UNITED STATES PATENT AND TRADEMARK OFFICE

APPLICATION NO.	FILING DATE	FIRST NAMED INVENTOR	ATTORNEY DOCKET NO.	CONFIRMATION NO.
10/065,361	10/09/2002	William James Curtiss	201-1055	7869

Office Action Summary

Fig. 3

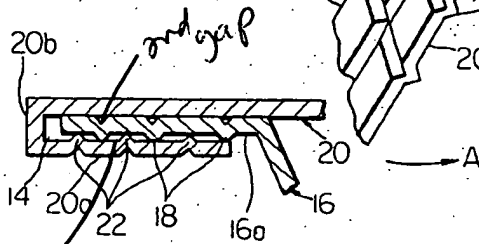
Polon discloses the claimed invention including an inner panel 14, an outer panel 12 and dimpled sections 26. The dimpled sections provide for the inner panel 14 and the inner portion 16 of the outer panel 12 to be standing off from each other by gaps 64. There is also a second gap, as indicated in the attached marked up copy of Figure 3, between the outer portion of the outer panel 12 and the inner panel 14.

Polon discloses the claimed invention including an inner panel 16, an outer panel 20 and dimpled sections 18. The dimpled sections provide for the inner panel 16 and the inner portion 20a of the outer panel 20 to be standing off from each other by gaps. There is also a second gap between the outer portion of the outer panel 20 and the inner panel 16. See the in the attached marked up copy of Figure 3.
